Re: Approval of the Final Plat of Schutter Farm First Addition, a proposed nine (9) lot residential subdivision located in part of the SE $\frac{1}{4}$ of Section 7, Pleasant Valley Township, north of Valley Drive, west of Spencer Creek and east of Spencer Road.

PLANNING & ZONING COMMISSION
STAFF REPORT
July 19, 2011

STAFF REVIEW: Staff has reviewed this Final Plat request for compliance with the requirements of the Subdivision Regulations, the Zoning Ordinance and the six conditions of Preliminary Plat approval. Those six conditions were:

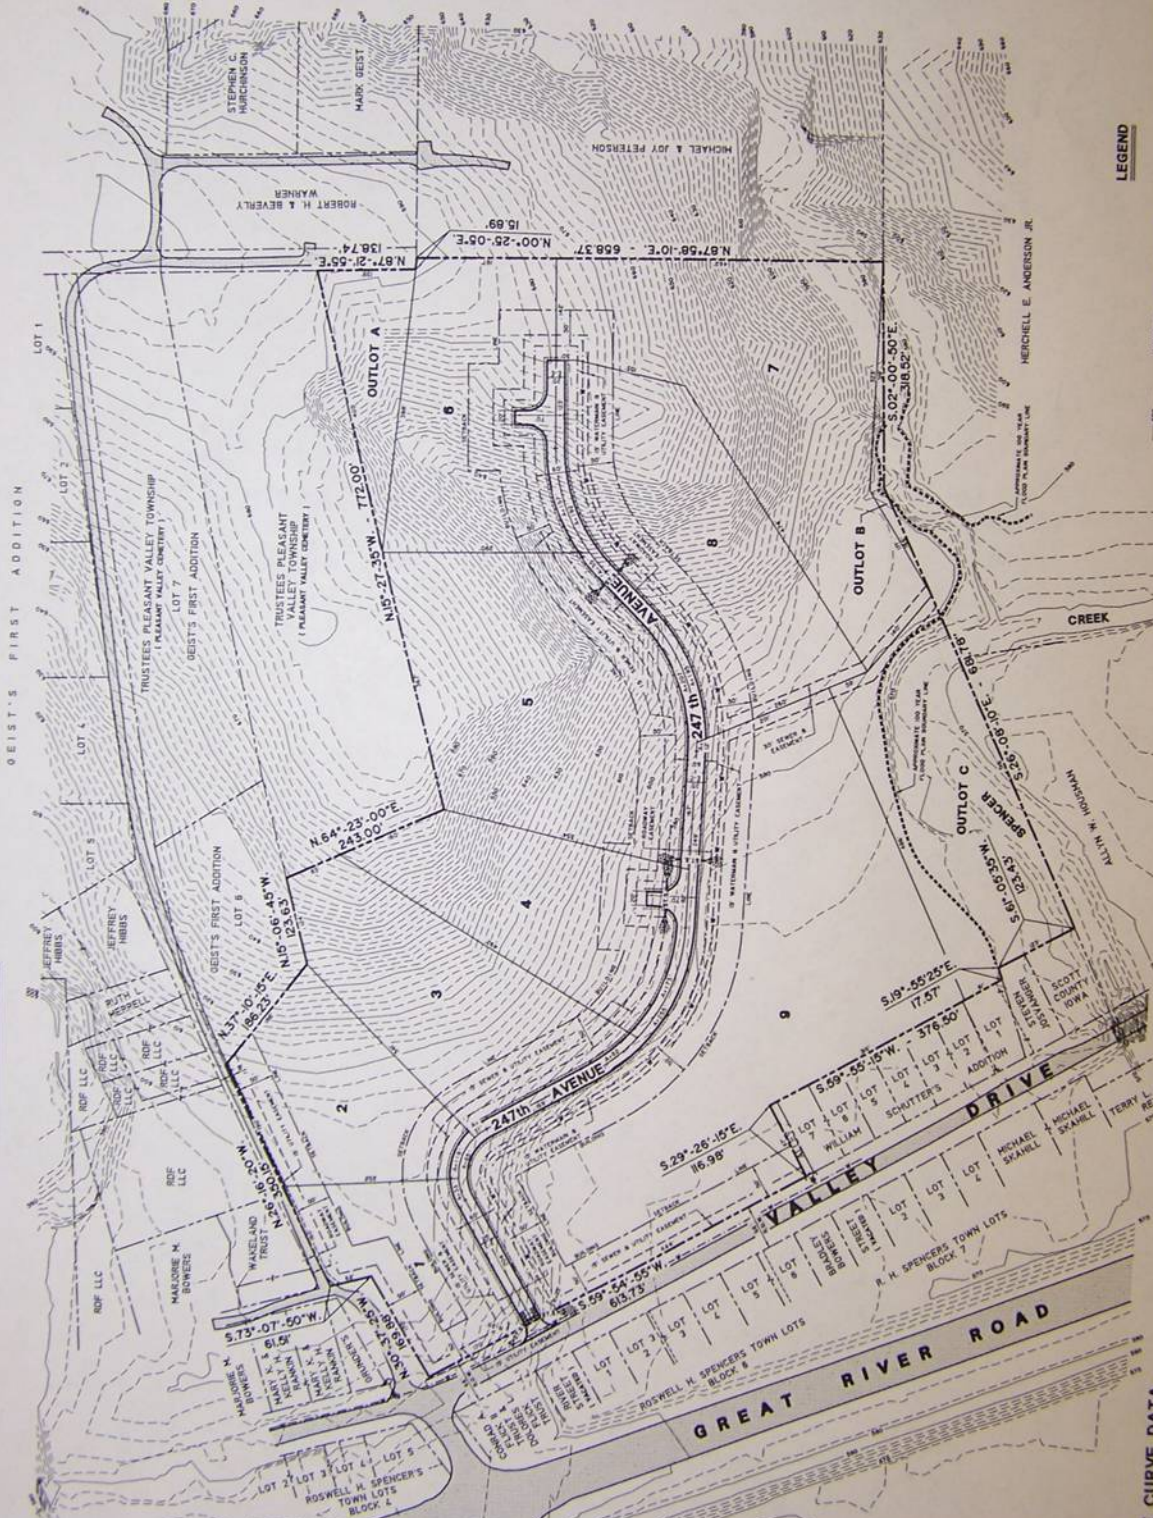
The proposed private access road slightly exceeds the maximum length for a dead end street. The variance to the Subdivision Regulations to allow the proposed road length was approved in conjunction with the Preliminary Plat.

All of the proposed nine development lots would have access to an interior road that would end with a hammerhead turnaround. There is also an intermediate turnaround, as required by the City of Bettendorf, mid way along the length of the road. The interior street intersects with Valley Drive in a location determined to be acceptable by the County Engineer. The subdivision ordinance requires this proposed street to be numbered as an avenue in accordance with the County's E-911 addressing regulations. 247th Avenue has been assigned as the name of the road and is shown on the Final Plat.

The street construction plans have to been submitted and approved by the County Engineer. The construction of that road and other subdivision improvements is proceeding and is scheduled to be completed prior to Final Plat approval by the Board of Supervisors. The developer has submitted covenants covering road maintenance for this private road.

RECOMMENDATION: Staff recommends that the Final Plat for Schutter Farm Addition be approved with the condition that the subdivision infrastructure improvements be completed or a surety bond posted prior to Final Plat approval by the Board of Supervisors.
